# Access Compliance Report

## Public Rights-of-Way

### (Curb Ramps)

Intersection ID: 10772	Main Street: E_36TH_ST	Cross Street: THE_PLAZA	Location: W
ADA ID: F38BCF5F8BF0	Ramp Type: Perp	Initial Pass/Fail: Fail	Overall Compliance: No
Severity Score: 8.75			
Codes/Mitigation Info/Possible Solution		Field Measurements/Component Compliance

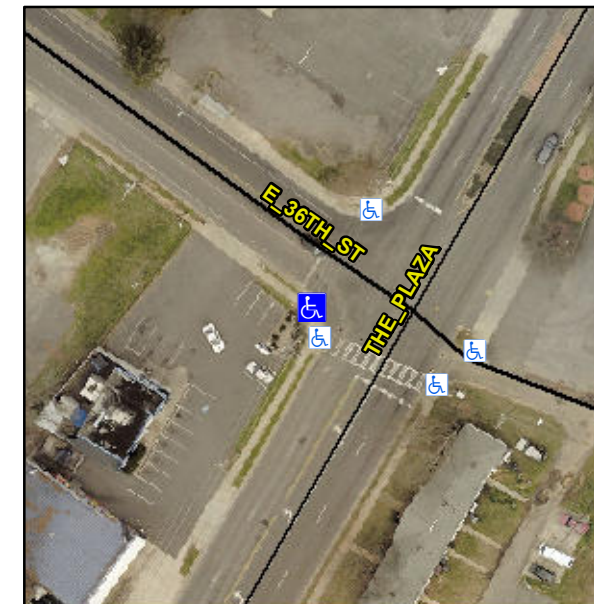
**Not Found, R304.5.1**

Compliance	Description	Data	Compliance	Description	Data
N/A	Ramp Length (in)	34.5	Yes	Ramp Slope (%)	6.8
No	Ramp Width (in)	41.0	Yes	Ramp XSlope (%)	1.4
N/A	Flare Type LT	N/A	N/A	Flare Type RT	N/A
N/A	Flare Slope LT (%)	N/A	N/A	Flare Slope RT (%)	N/A
N/A	Flare Traversable LT?	N/A	N/A	Flare Traversable RT?	N/A
N/A	Landing Length (in)	N/A	N/A	DWS Provided?	N/A
N/A	Landing Width (in)	N/A	N/A	DWS Contrast?	N/A
N/A	Landing Slope (%)	N/A	N/A	DWS Length (in)	N/A
N/A	Landing X Slope (%)	N/A	N/A	DWS Full Width?	N/A
N/A	Landing Curb? (Y/N)	N/A	N/A	DWS Offset (in)	N/A
N/A	Shared Landing?	N/A			
N/A	Gutter Ponding?	N/A	N/A	Gutter Slope (%)	N/A
N/A	Gutter Lip Ht (in)	N/A	N/A	Gutter X Slope (%)	N/A
N/A	Painted X Walk1?	Yes	N/A	Painted X Walk2?	N/A
	X Walk 1 Direction	To NE		X Walk 2 Direction	N/A
N/A	X Walk 1 Width (in)	110.5	N/A	X Walk 2 Width (in)	N/A
	X Walk 1 Slope (%)	0.5		X Walk 2 Slope (%)	N/A
	X Walk 1 X Slope (%)	0.7		X Walk 2 X Slope (%)	N/A

**Remove & Replace Entire Ramp.**
